UNITED STATES PATENT AND TRADEMARK OFFICE

APPLICATION NO.	FILING DATE	FIRST NAMED INVENTOR	ATTORNEY DOCKET NO.	CONFIRMATION NO.
10/630,210	07/30/2003	Joseph E. Mattingly JR.	AMC.P.US0021	2012
26360	7590	02/21/2006	EXAMINER	
RENNER, KENNER, GREIVE, BOBAK, TAYLOR & WEBER FIRST NATIONAL TOWER FOURTH FLOOR 106 S. MAIN STREET AKRON, OH 44308			COOLEY, CHARLES E	
			ART UNIT	PAPER NUMBER
			1723

Office Action Summary	Application No.	Applicant(s)	
	10/630,210	MATTINGLY, JOSEPH E.	
	Examiner	Art Unit	
	Charles E. Cooley	1723

NON-FINAL OFFICE ACTION

FIG. 3

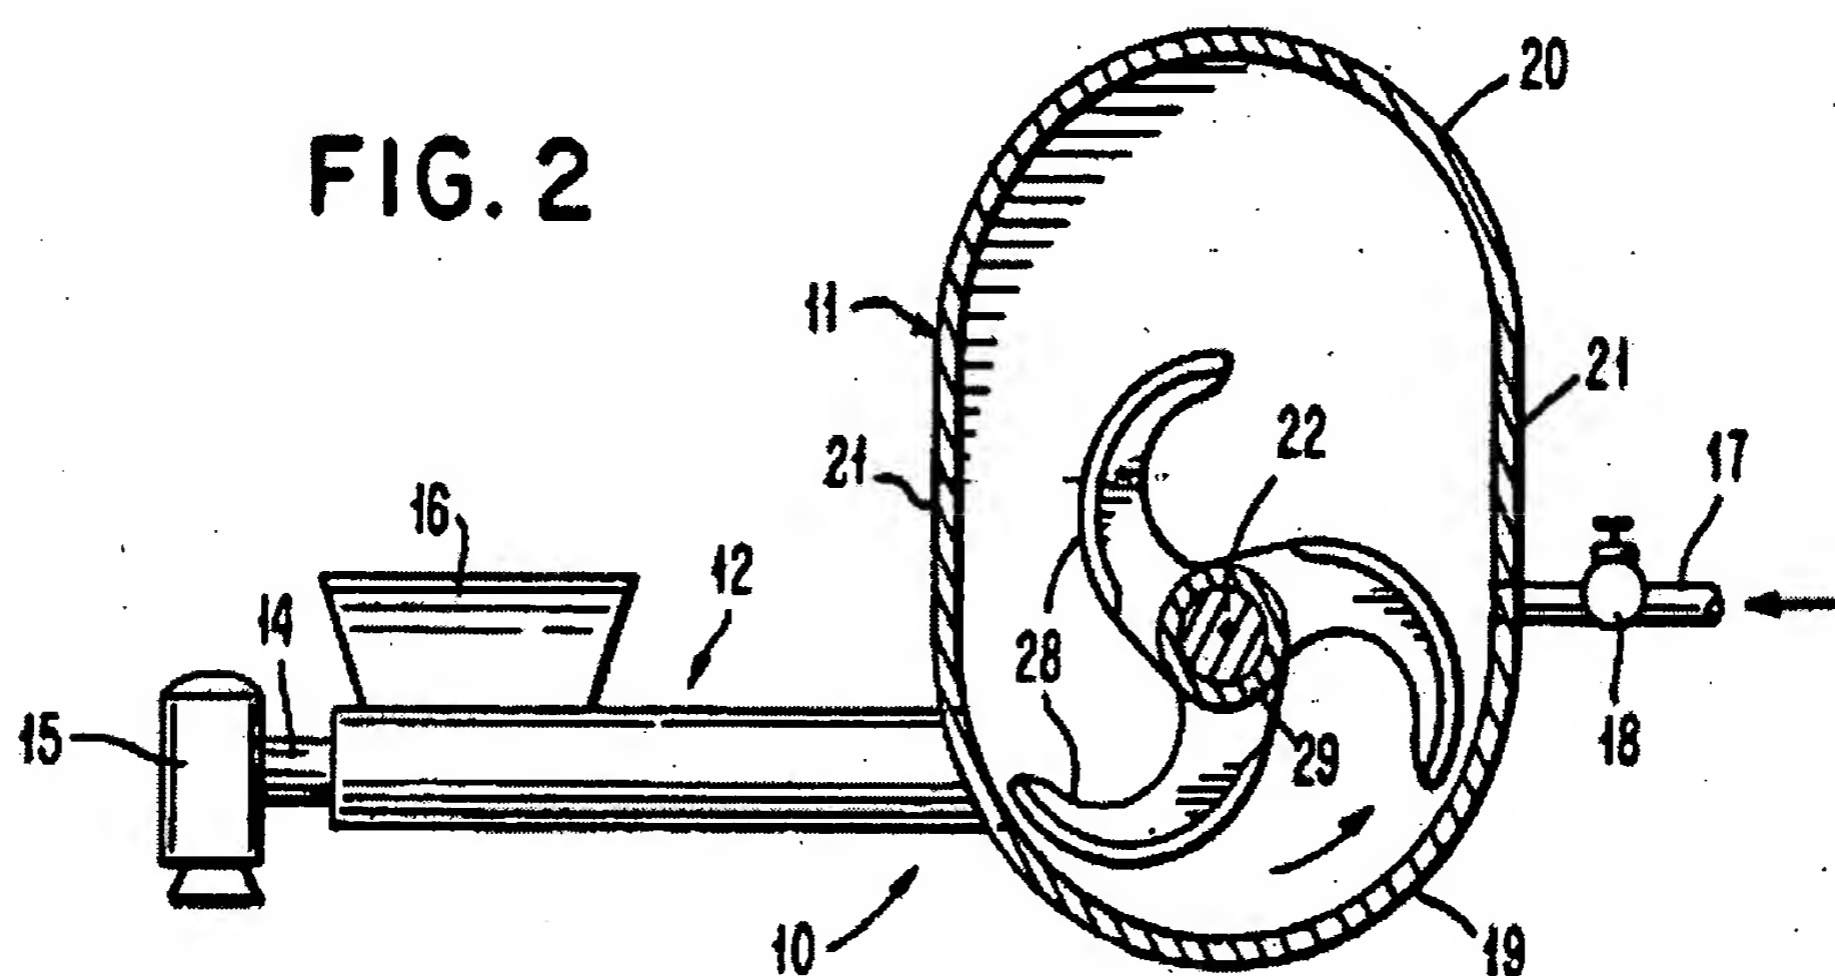
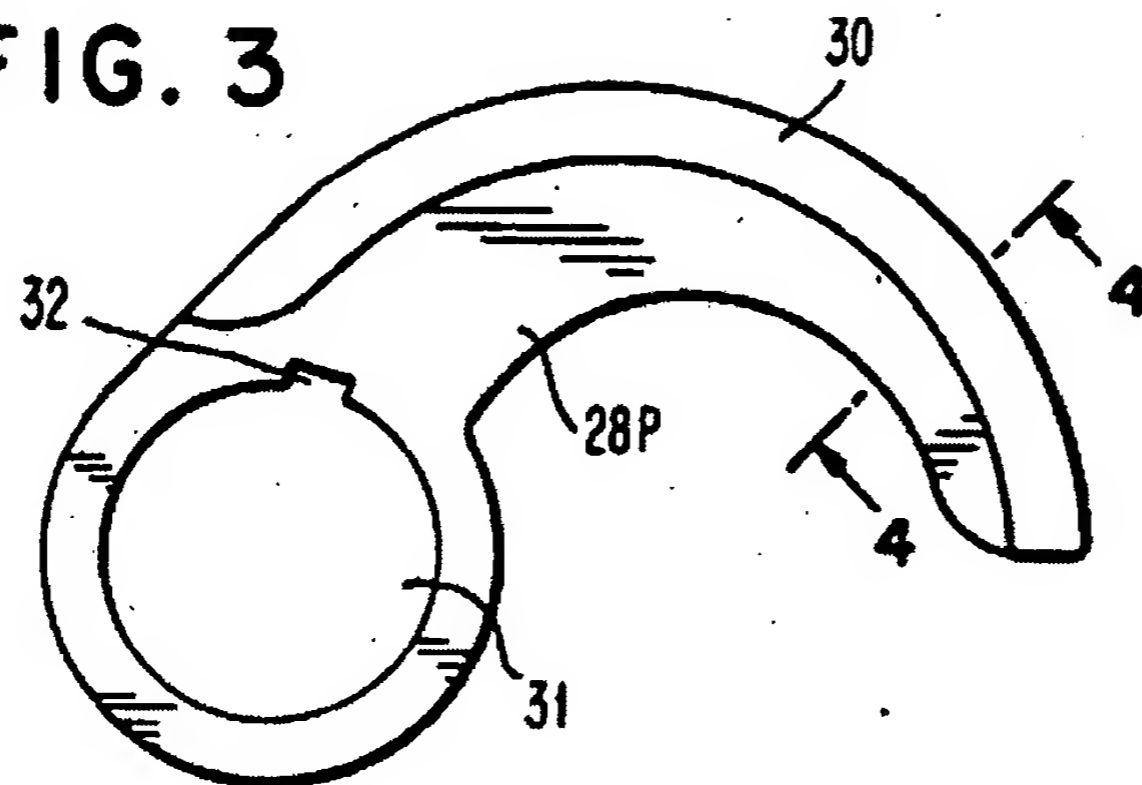
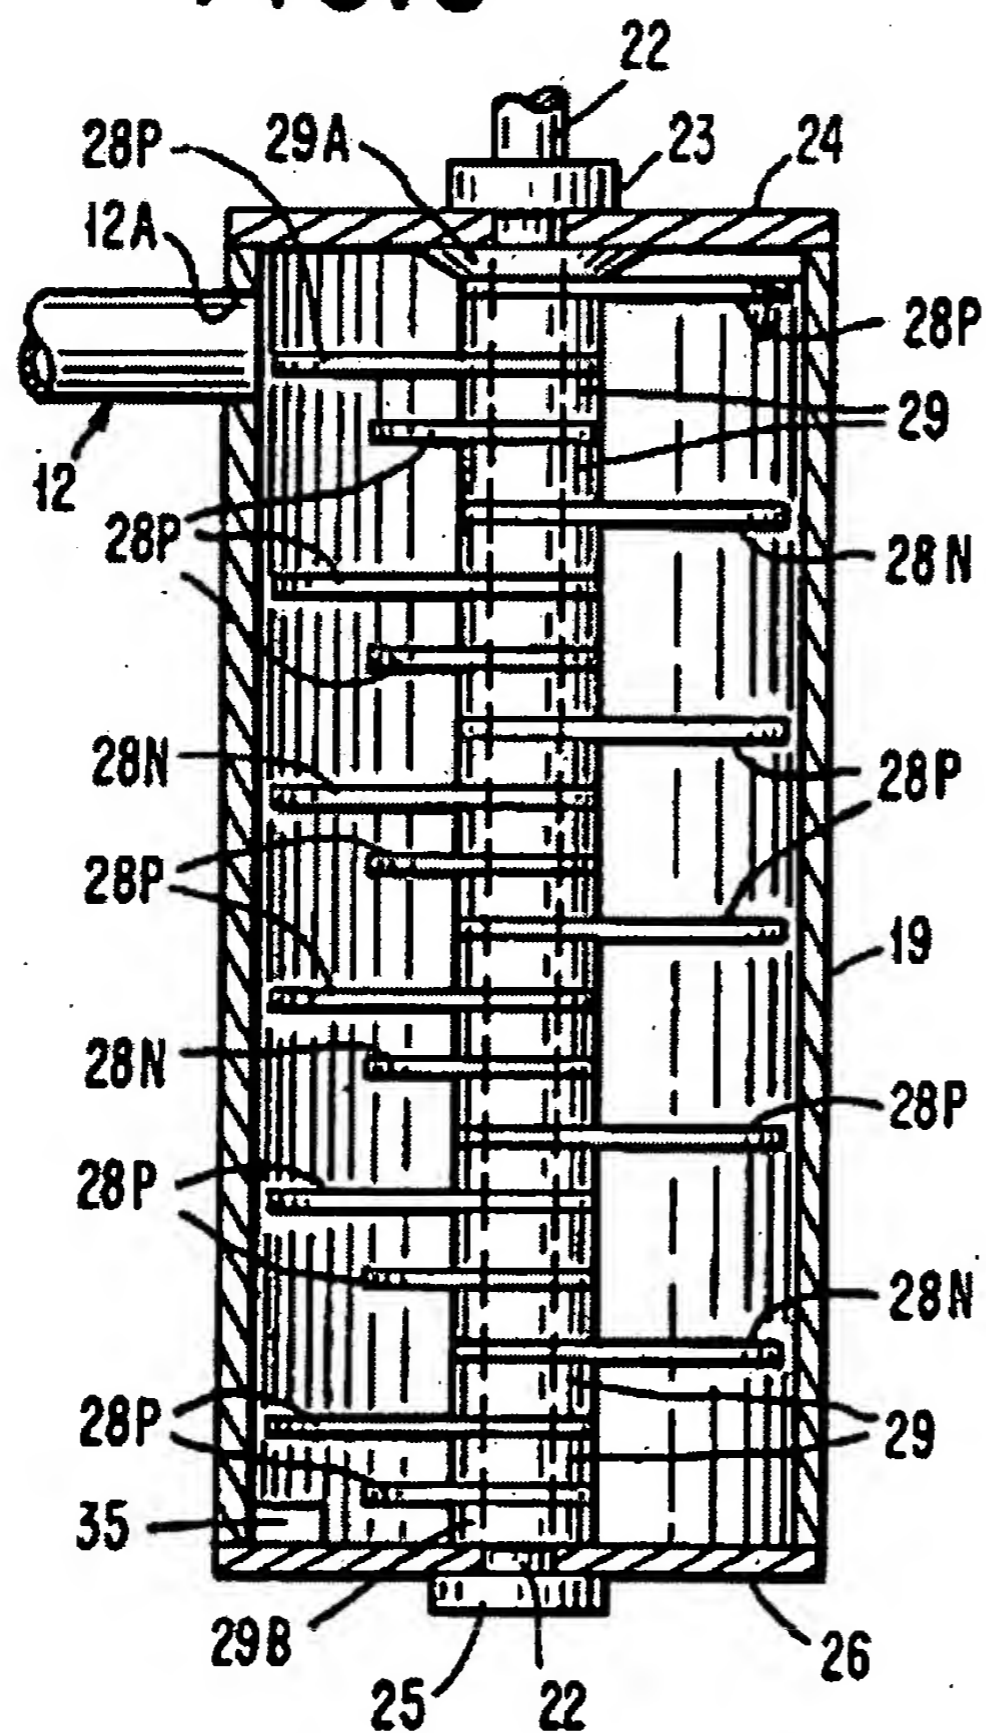
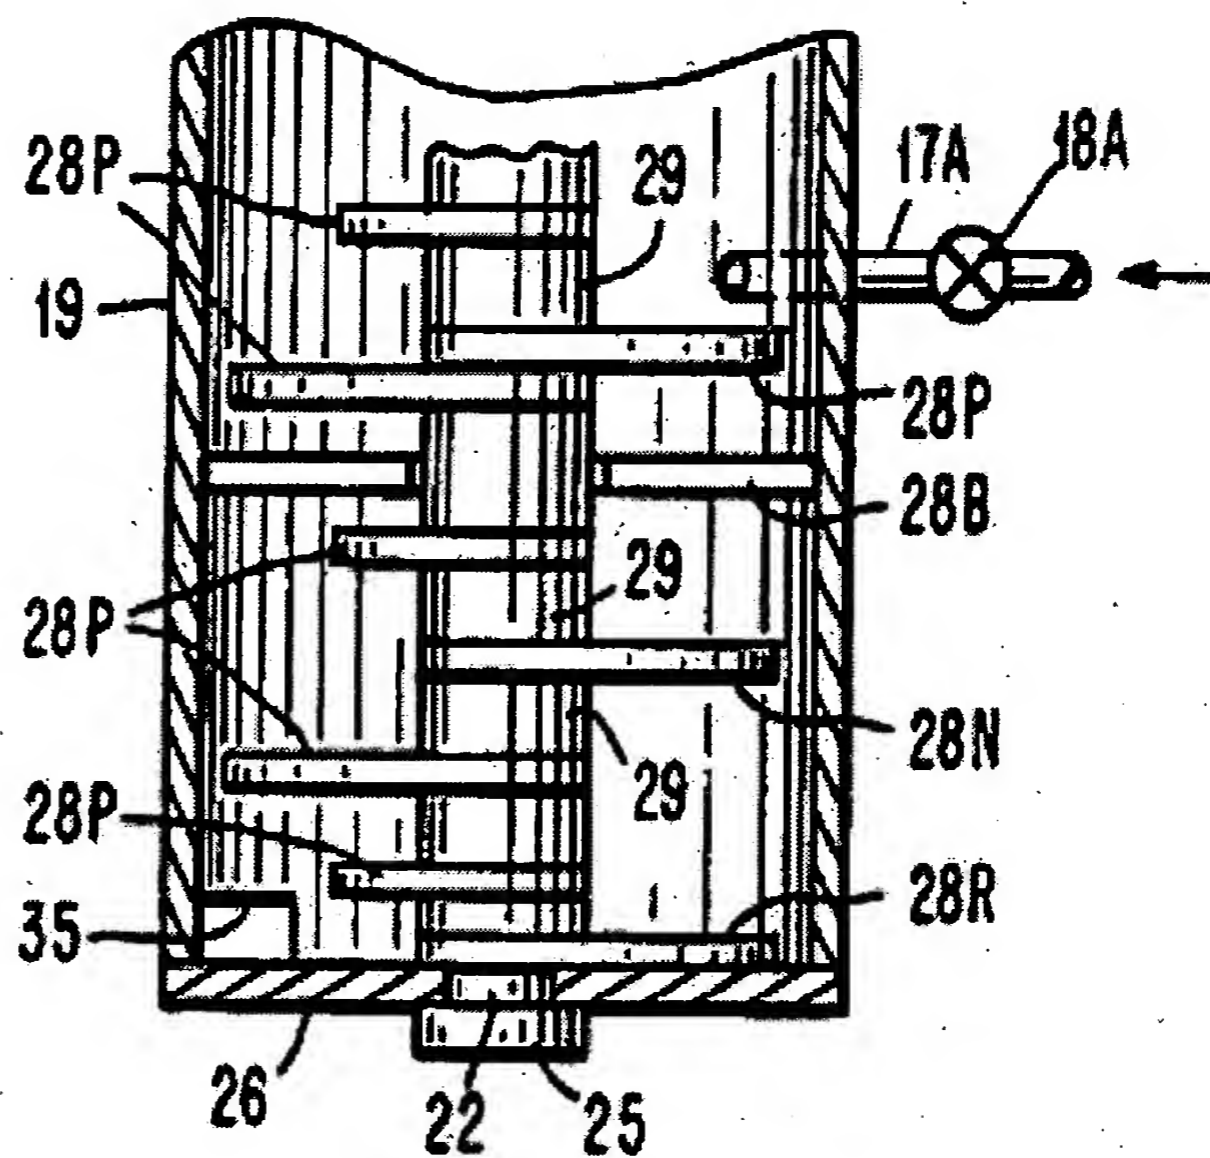
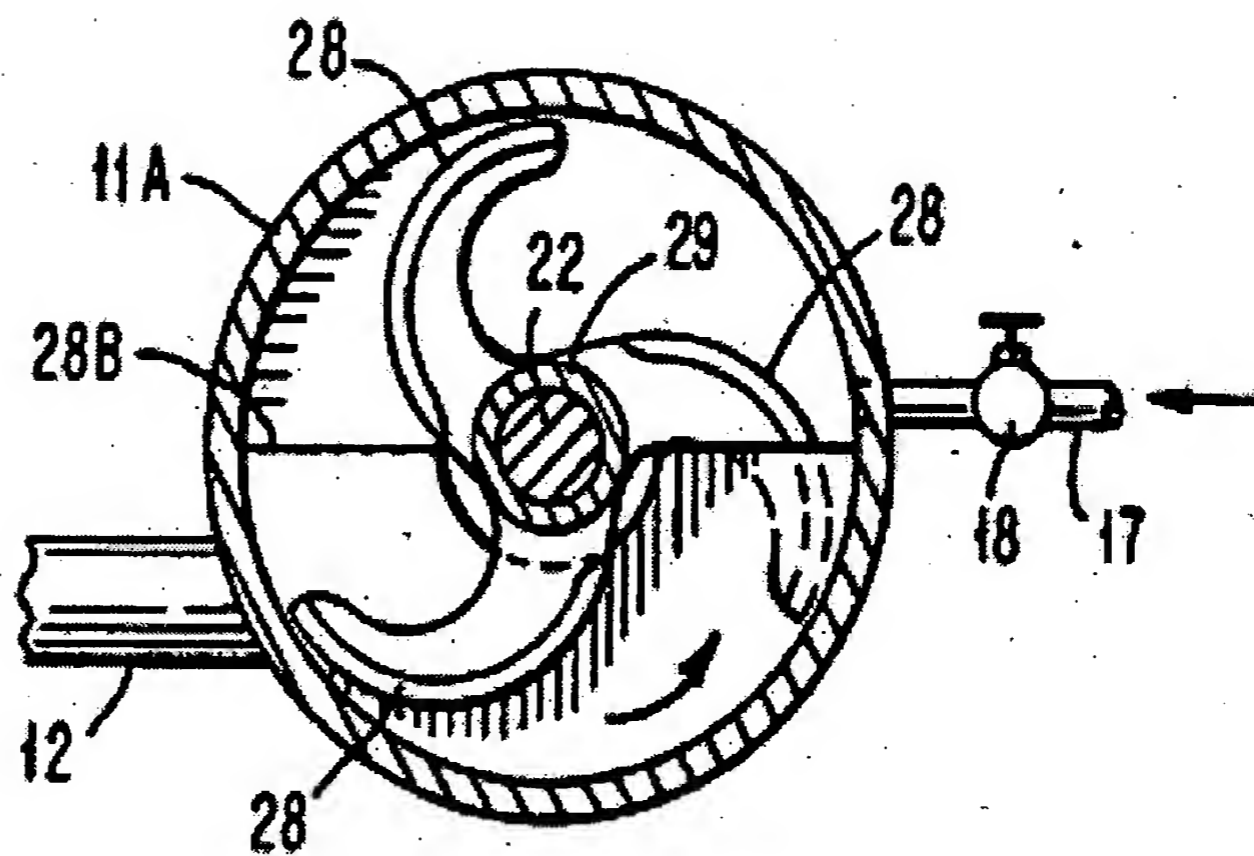
8. **Claims 1, 2, 4, 5, 6, 9, 10, 12, 13, 14, 15, 16, 17, 18, 19, and 21 are rejected under 35 U.S.C. 102(b) as being anticipated by D'Alterio (US 5,100,240).**

The patent to D'Alterio discloses an element (one or more of members 28, 29) as seen in the Figures below comprising one or more lobes extending from a central

portion adapted to receive a shaft 22; wherein the one or more lobes has an outer periphery ridge and first and second lateral sidewalls, wherein one of said lateral sidewalls (denoted at 28P - see Fig. 3) of said at least one lobe is concave between said outer periphery ridge and said central portion, wherein the other of said lateral sidewalls 30 on each lobe is convex between said outer periphery ridge and said central portion; the element may comprise one or more of members 28 and/or 29 and thus includes two or three or more lobes as seen in Figs. 6-7; said element is twisted (Fig. 3); the element constituting a block comprising a plurality of elements (multiple sets of members 28 and/or 29), wherein the block includes at least two kneading elements (e.g., 28P, 28P - Fig. 6) wherein one of the lateral sidewalls on at least one lobe is concave between said outer periphery ridge and said central portion; wherein the block comprises N number of kneading elements adjacent to each other (e.g., N number of 28P, 28N - Fig. 6), wherein all the elements have at least one lobe having first and second lateral sidewalls and wherein one of the lateral sidewalls on said at least one lobe is concave between said outer periphery ridge and said central portion; wherein at least the first element (an upstream member 28P) of the block has at least one lobe having first and second lateral sidewalls and wherein one of the lateral sidewalls on said at least one lobe is concave between said outer periphery ridge and said central portion; wherein at least the last element (a downstream member 28P) of the block has at least one lobe having first and second lateral sidewalls and wherein one of the lateral sidewalls on said at least one lobe is concave between said outer periphery ridge and said central portion; wherein at least the first and last elements (an upstream member

28P and a downstream member 28P) of the block has at least one lobe having first and second lateral sidewalls and wherein one of the lateral sidewalls on said at least one lobe is concave between said outer periphery ridge and said central portion; wherein each element (28, 29) is twisted in the same direction.

FIG.15

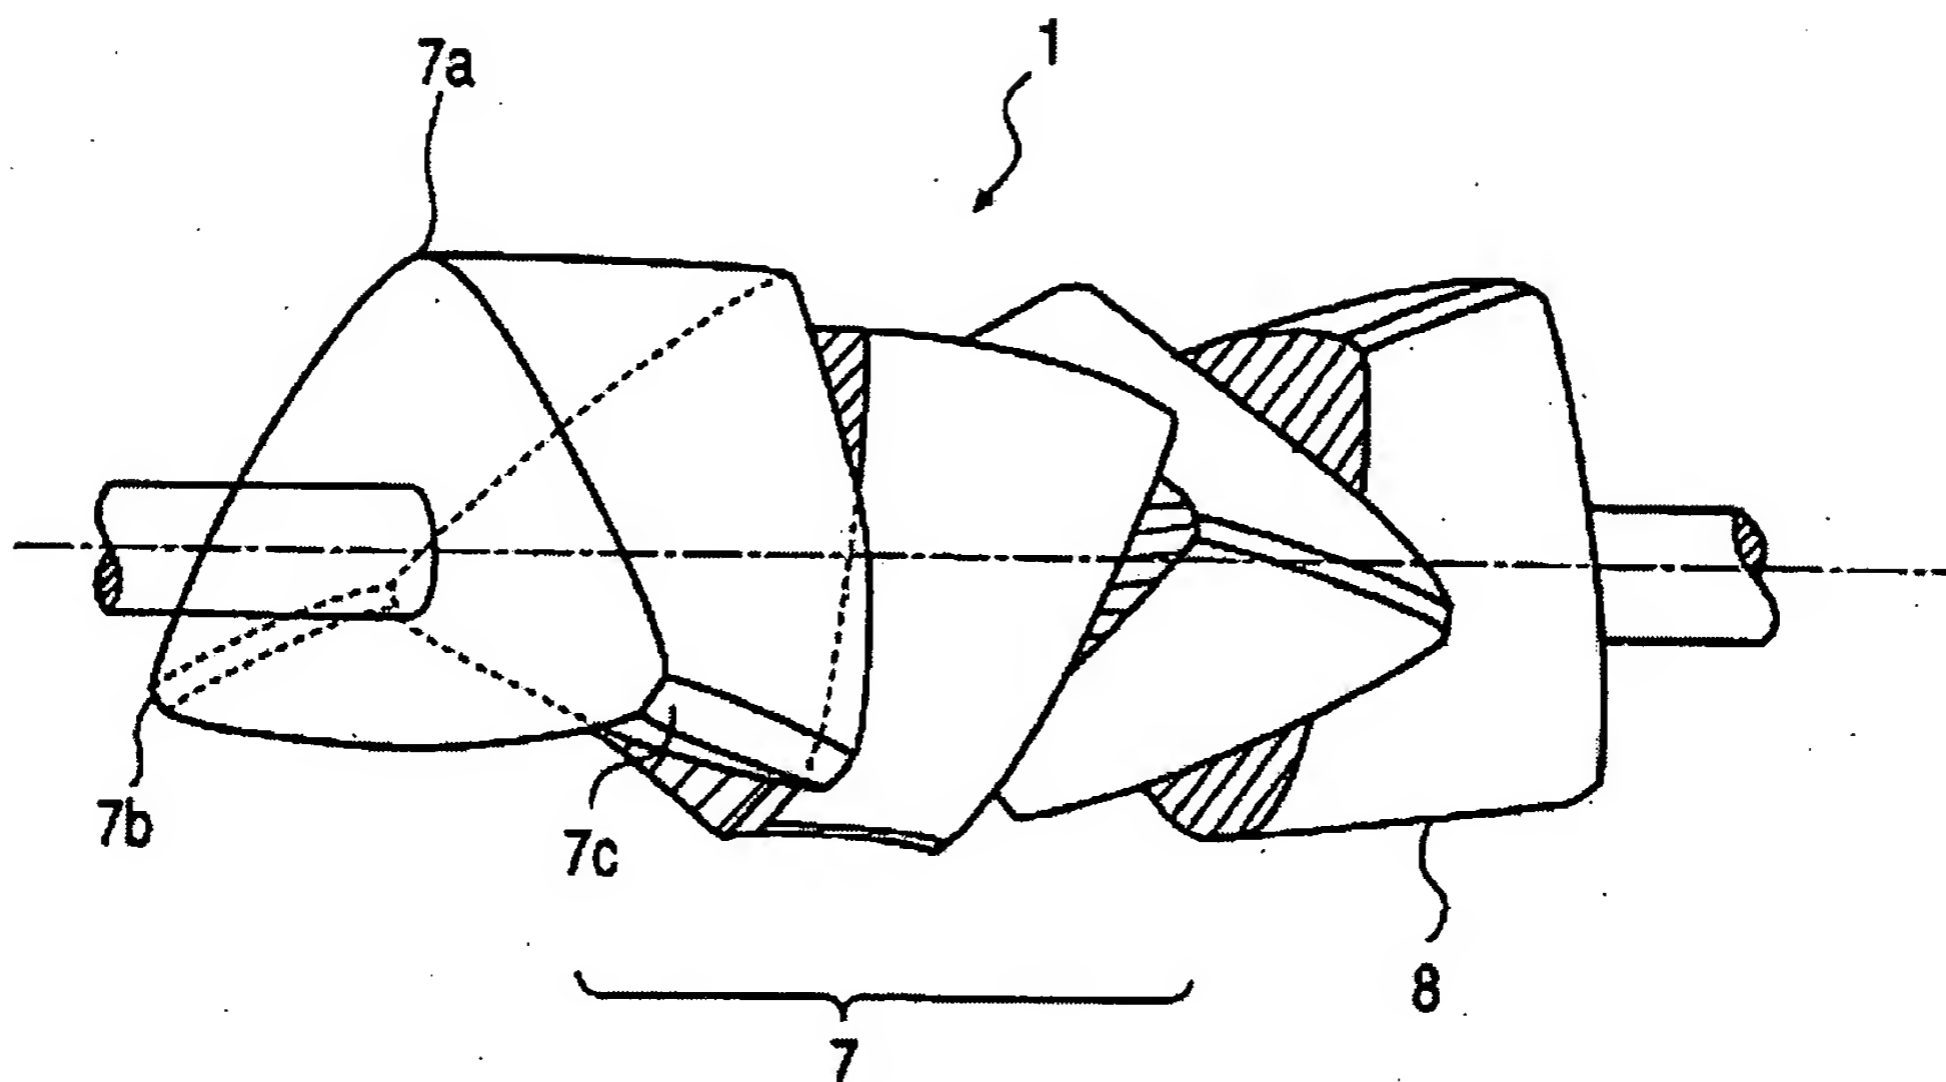
9. Claims 1, 2, 4, 5, 6, 7, 8, 9, 10, 12, 13, 14, 15, 16, 17, 18, 19, and 21 are rejected under 35 U.S.C. 102(b) as being anticipated by Inoue et al. (US 5,984,516).

The patent to Inoue et al. discloses an element (one or more of members 7) as seen in the Figures below comprising one or more lobes (7a-7c) extending from a central portion adapted to receive a shaft (Fig. 15); wherein the one or more lobes has an outer periphery ridge and first and second lateral sidewalls, wherein one of said lateral sidewalls (proximate D in Fig. 3) of said at least one lobe is concave between said outer periphery ridge and said central portion, wherein the other of said lateral sidewalls on each lobe is convex between said outer periphery ridge and said central portion (Fig. 3); the element may comprise one or more of members 7 and includes two or three or more lobes as seen in Figs. 3 and 15; said element is twisted (Fig. 3); wherein said element has an axial depth greater than the diameter of the shaft receiving bore (Fig. 15); the element constituting a block comprising a plurality of elements (multiple members 7 - Fig. 15), wherein the block includes at least two kneading elements 7, 7 wherein one of the lateral sidewalls on at least one lobe is concave between said outer periphery ridge and said central portion; wherein the block comprises N number of kneading elements 7 adjacent to each other (e.g., N number of 7 - Fig. 15), wherein all the elements have at least one lobe having first and second lateral sidewalls and wherein one of the lateral sidewalls on said at least one lobe is concave between said outer periphery ridge and said central portion; wherein at least the first element (an upstream member 7) of the block has at least one lobe having first and second lateral sidewalls and wherein one of the lateral sidewalls on said at least

one lobe is concave between said outer periphery ridge and said central portion;
wherein at least the last element (a downstream member 7) of the block has at least
one lobe having first and second lateral sidewalls and wherein one of the lateral
sidewalls on said at least one lobe is concave between said outer periphery ridge and
said central portion; wherein at least the first and last elements (an upstream member 7
and a downstream member 7) of the block has at least one lobe having first and second
lateral sidewalls and wherein one of the lateral sidewalls on said at least one lobe is
concave between said outer periphery ridge and said central portion; wherein each
element 7 is twisted in the same direction (Fig. 15).
